MEMORANDUM

SUBJECT: LAND-2019-00658; Avalon Eaves Redmond Campus

REQUEST: Formal Application Review Meeting

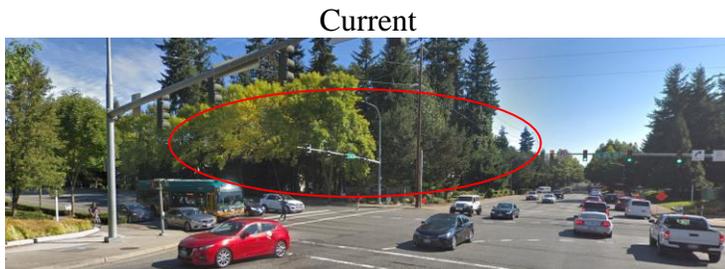
- 1) **Corner Gateway/Design:** The current northeast corner of NE 40th Street and 156th Avenue NE contains multiple evergreen trees that create a “green wall” for the Avalon Redmond Eaves Apartment complex behind it. The proposal requires frontage improvements and pulling the building close to the intersection, existing green wall is planned to be removed.

With the existing site being fairly wooded; then transitioning to a new midrise as shown below, the building shall command strong design language that is separate look from Downtown Redmond. The design should also complement the work that Microsoft is establishing to the South and East by creating a gateway for commuters, visitors and residents coming from of State Route 520 and the future Redmond Technology Center Station.
